Monticello Nuclear Generating Plant
Docket 50-263
License No. DPR-22

Response to Requests for Additional Information Regarding the Monticello Nuclear
Generating Plant License Renewal Application (TAC No. MC6440)

RESPONSE TO NRC REQUEST FOR ADDITIONAL INFORMATION DATED SEPTEMBER 28, 2005

Figure 1
Relaxation of Irradiated Austenitic Steels & Ni-GE Mean Design Curve

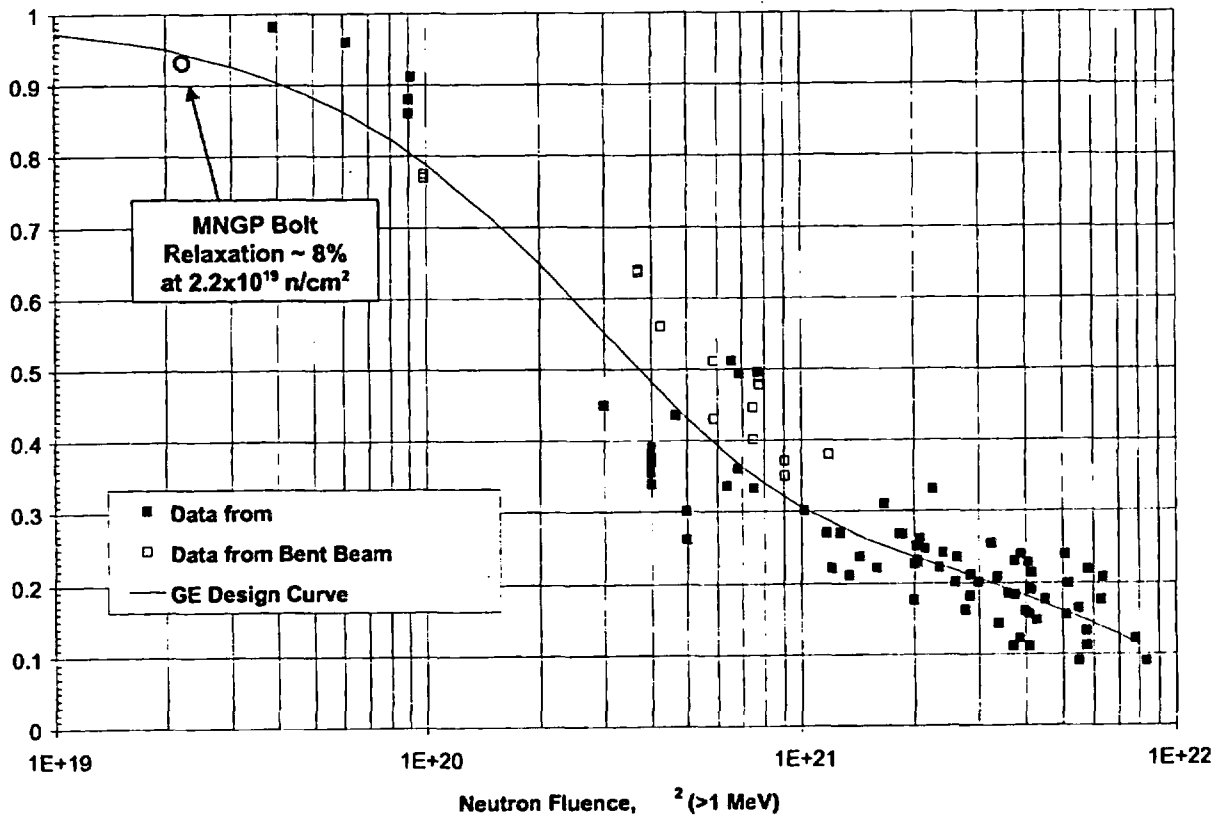
- a. Provide the stress-relaxation curves and their supporting data that were utilized to determine the percent relaxation of the rim holddown bolts at MNGP. Explain how this data was utilized to establish the curves.

- b. The staff requests that the applicant provide information regarding the material type, (i.e., type 304 or type 316, etc.), values of neutron flux and temperature related to the data cited in response to RAI 4.8-2(a) and compare them to the type of material, neutron flux and temperature values of the rim holddown bolts at MNGP. If the type of material, neutron flux or temperature values for the rim holddown bolts at MNGP are different than that for the data, evaluate the impact of these differences on the predicted stress relaxation values of the rim holddown bolts at MNGP.

- c. Describe the load on the specimens used to develop the stress relaxation curves in response to RAI 4.8-2(a). Explain why these specimens are applicable for use in determining the axial stress relaxation in the rim holddown bolts.

Figure 1, "The Relaxation of Irradiated Austenitic Steels and Ni," shows the GE mean design curve along with the data used for its derivation. The curve is based on a model that assumed a stress-linear, primary plus secondary creep law form, and was fit to the shown data using stepwise multiple regression. The data presented as closed symbols are from measurements made on springs, and the data shown as open symbols are measurements made using bent-beam specimens.

- b. The core plate hold-down bolts used in MNGP are Type 304 stainless steel. The data used to develop the curve in Figure 1 includes several austenitic materials. However, based on the following discussion, the use of data from other austenitic material is considered appropriate, as shown in Figure 1.

More than 80% of the tests, shown in Figure 1 were conducted at a temperature of 550°F and a majority of these were conducted in an operating BWR environment. The other tests, were conducted at either 570 or 600°F which is expected to produce more relaxation. Since such a large portion of the data was conducted at typical BWR operating conditions, the data temperature is considered fully representative of the core plate bolts.

- d. A MNGP specific bolt average fluence of 2.2×10^{19} n/cm² (E>1MeV) was calculated at the peak fluence location. Given that the fluence on the core plate bolts varies depending on the azimuthal location, with a significant fraction of the bolts at less than the peak fluence, this provides an additional conservatism for most bolt locations. The MNGP specific fluence of 2.2×10^{19} n/cm² (E>1MeV) was then compared to the original, hand drawn GE design curves to determine a value of 8% relaxation. Figure 1 is a re-plotted version of the GE design curve that shows a computer generated curve fit of the same data. The value of 8% relaxation is conservative relative to the statistical curve fit shown in Figure 1.
